ECE/TRANS/WP.29/GRE/2007/66 4 September 2007

COLLECTIVE AMENDMENTS Regulations Nos. 6, 7 and 48

Proposal for draft Corrigendum 2 to Supplement 12 to the 02 series of amendments Regulation No. 7 (Front and rear position (side) lamps, stop lamps and end-outline marker lamps)

Transmitted by the expert from France

(a) Vertical light distribution of position lamps with a permissible mounting height x mm above the ground: 15° above the horizontal and α° below the horizontal so that:

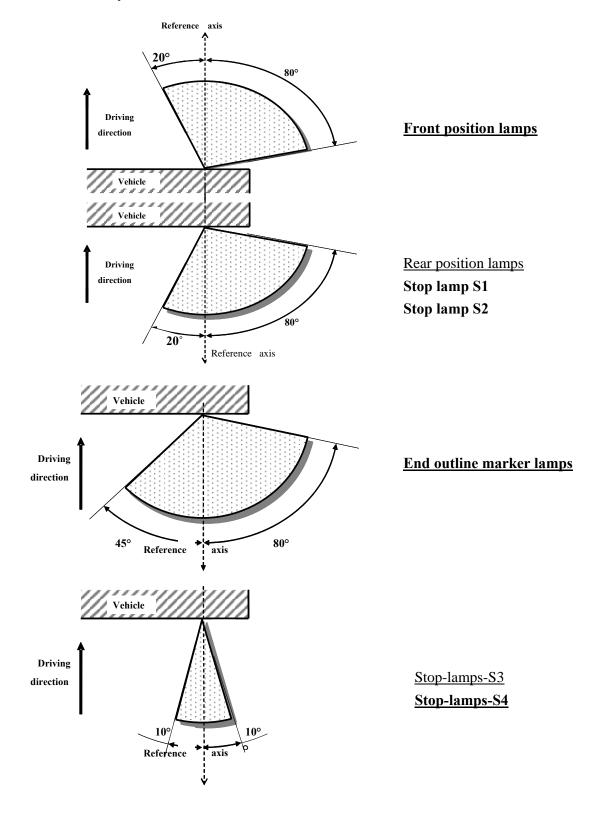
$$x \ge 850 \text{ mm}: \qquad \alpha = 15^{\circ}$$
 if
$$850 \ge x \ge 750 \text{ mm}: \quad \text{it may be reduced to } \alpha = 5^{\circ} + 0.1(x - 750)^{\circ}$$
 if
$$x < 750 \text{ mm}: \quad \text{it may be reduced to } \alpha = 5^{\circ}$$

where x is the lower height of the lamp above the ground.

- (b) The limit of 750 mm in eight is somewhat arbitrary and creates a threshold problem. With only one millimetre above the limit, the angle of visibility jumps from 5° under the horizontal to 15°. The formulae proposed in Annex 1 (a) create a smooth transition between these two angles and remove the threshold effect.
- (c) No modification is proposed for the visibility angles of the end-outline marker lamps.

(d) Horizontal visibility

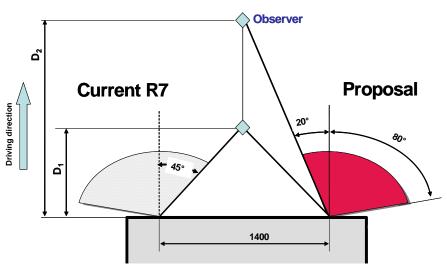
The current visibility requirements were written in the early 1970s. They were easily fulfilled in those times because the shapes of the vehicles were simple and rather boxy. Recent styling trends based on better aerodynamics and pedestrian protection lead to contoured shapes making the fulfilment of the 15 down and 45 inboard (15D-45inboard) visibility requirement impossible.

(a) Reducing the interior visibility angle from 45° to 20° has a minimum impact on the distance of visibility of the vehicle observed along its longitudinal median plan. In the case of a vehicle with 1400 mm between the reference axis of the front position lamps, this angular reduction, as seen by an observer standing on the median longitudinal plan of the vehicle, leads to a minimal change of just 1.22 m:

With the current visibility angle, the lamp is visible at $D_1 = 1400 \times 0.5 \cot 45^\circ$.

With the proposed visibility angle, the lamp is visible at $D_2 = 1400 \times 0.5 \text{ cotg } 20^\circ$.

The "danger" distance is increased by a modest D_2 - D_1 = 1400 x 0.5 (cotg 20° - cotg 45°) = 1220 mm

This angular modification allows more pedestrian-friendly front ends. It helps improving the aerodynamics of the vehicle, thus reducing the fuel consumption.
